RESPONSE TO REQUEST FOR ADDITIONAL INFORMATION

US-APWR Design Certification

RAI NO.: NO. 960-6709 REVISION 0
SRP SECTION: 03.07.02 – Seismic System Analysis
APPLICATION SECTION: 3.7.2
DATE OF RAI ISSUE: 09/24/2012

QUESTION NO. 03.07.02-212:

RAI 960-6709 QUESTION 03.07.02-212
ATTACHMENT 1

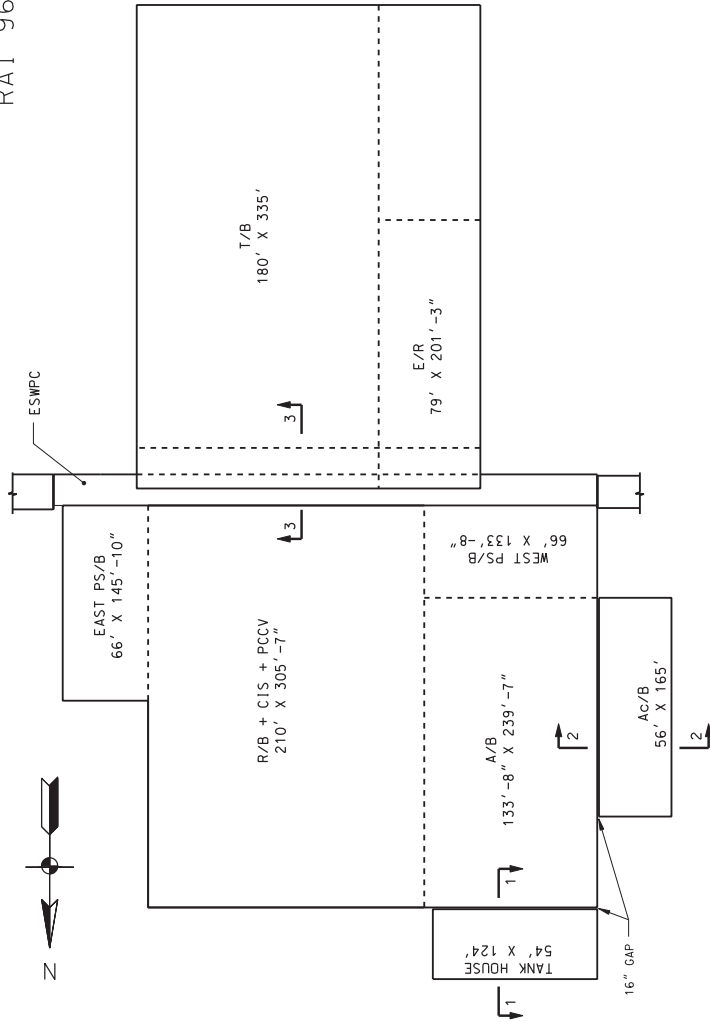
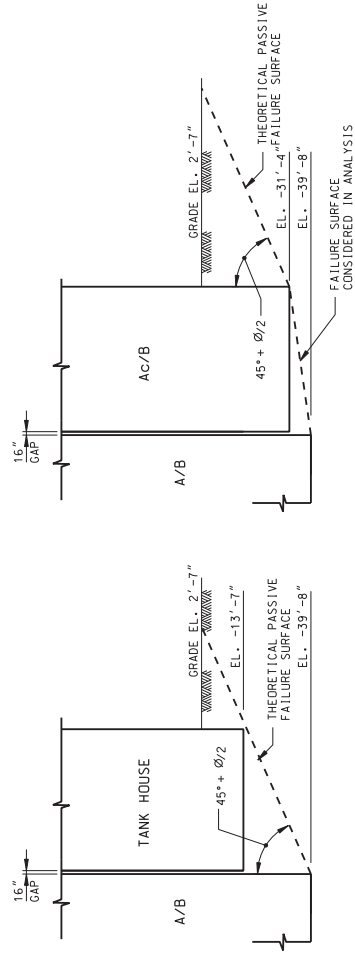
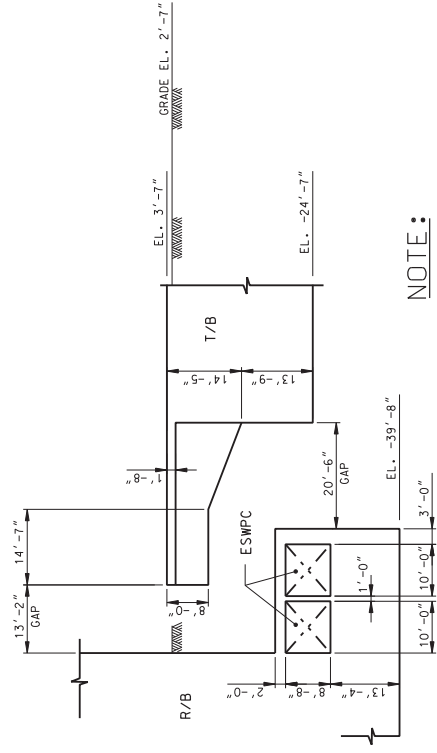
- a) In order to judge the adequacy of the gaps, to document which structures are adjacent to each other, and to document the structures that share a common basemat, the applicant is requested to provide a figure that shows those information. The figure should include all of the Seismic Category I structures and non-Seismic Category I structures at the plant site, the boundary of the separate concrete basemats, and the magnitude of the gaps between adjacent basemats (below grade and above). The structures should include those within the MHI USAPWR design certification and those that are within the COL application scope.

- a) A figure including a plan view and vertical sections for the Standard Plant structures is provided in Attachment 1. The exact locations of the structures within the Combined License (COL) Applicant's scope are site specific. Therefore these structures could not be included in the figure. Adequacy of the gaps between the site specific structures and the Standard Plant structures are to be addressed by the COL

2. The gap between the R/B complex basemat and the turbine building (T/B) complex basemat is much larger (see Attachment 1), so there is no danger of contact between the structures' basemats due to gap closure. A potential issue is the increase in pressure in the backfill in the gap due to the two structures (R/B complex and T/B complex) sliding toward each other. The nonlinear sliding analysis provides a conservative estimate of the relative displacements of the R/B complex and the T/B complex and resulting gap closure (see the answer to Question c, below). This conservative estimate is then used to calculate the increase in pressure on the structural walls adjacent to the gap, due to compression of the backfill in the gap. These pressures are used for the design of structural below grade walls.

The gap between the R/B complex and the T/B is much larger, on the order of 13 feet (see Attachment 1 provided as part of the Answer to part a) of this question), therefore there is no concern regarding structure hammering. The gap closure due to sliding is calculated to estimate the increase in pressure on the structural walls adjacent to the gap, due to compression of the backfill in the gap. This gap closure is addressed as follows: For each of the two structures, nonlinear sliding analyses are performed for six generalized layered subgrade profiles and five acceleration time histories compatible with the certified seismic design response spectra (CSDRS). At each time instant, the total displacement for each structure is calculated as the vector sum of the sliding displacements in the X and Y directions. The nonlinear sliding analyses provide the maximum total displacements for each structure, each subgrade profile and each acceleration time history. The maximum expected sliding is calculated by statistical processing of results from different subgrade profiles and time histories, and represents the maximum value with exceedance probability of 2.5 percent (more details are provided in Section 5.4 of Technical Report MUAP 12002, Rev. 1). The gap closure is calculated as the absolute sum of the maximum expected values for the two structures (R/B complex and T/B complex). This calculation accounts for the possibility of the seismic waves to arrive in any direction, and for the two structures experiencing out of phase motions. Thus, the maximum gap closure due to sliding is $\Delta_{\text{sliding}}=0.75+0.2=0.95$ inches.
